# Service Bulletin

Bulletin No.: 20-NA-054

**Subject: Rear View Camera Guidance Lines Dim After Radio Replacement or Programming**

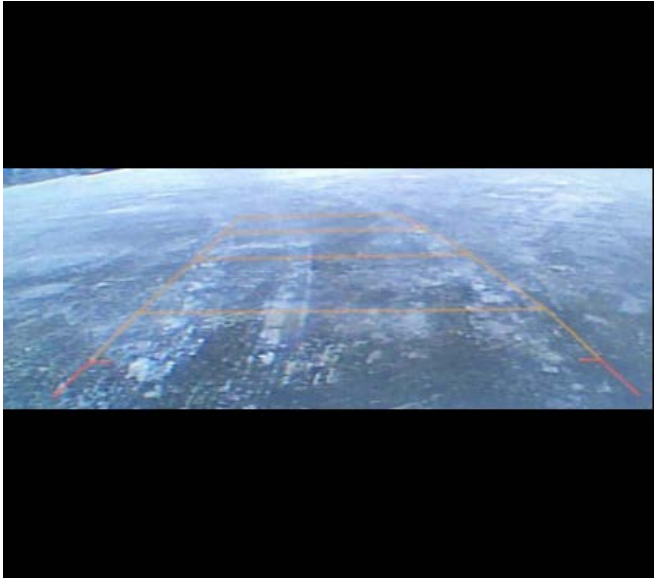
<b>Involved Region or Country</b>	North America
<b>Additional Options (RPOs)</b>	Equipped with Infotainment system IOS, IOT, or IOU
<b>Condition</b>	<p>Some customers, after having radio replacement or radio reprogramming, may report that the Rear-View Camera (RVC) guidance lines are not as bold as previously viewed, that they are faint, see-through, thinner, dim, or translucent; and they used to be more visible. A comparison between similar vehicle models may, or may not, show a difference in rear view camera guidance line appearance.</p> <p>Original design:</p>  <p>New design:</p>

<p style="text-align: right;">5525914</p>
<p><b>Cause</b></p>	<p>This may be caused by installing calibration files released in mid-2018 during radio replacement or reprogramming of the radio. The change to increase translucency was done to prevent the lines from obstructing objects in the field-of-view.</p>
<p><b>Correction</b></p>	<p>Do not attempt repairs. The thinner, lighter appearance of RVC guidance lines is operating to design intent.</p>
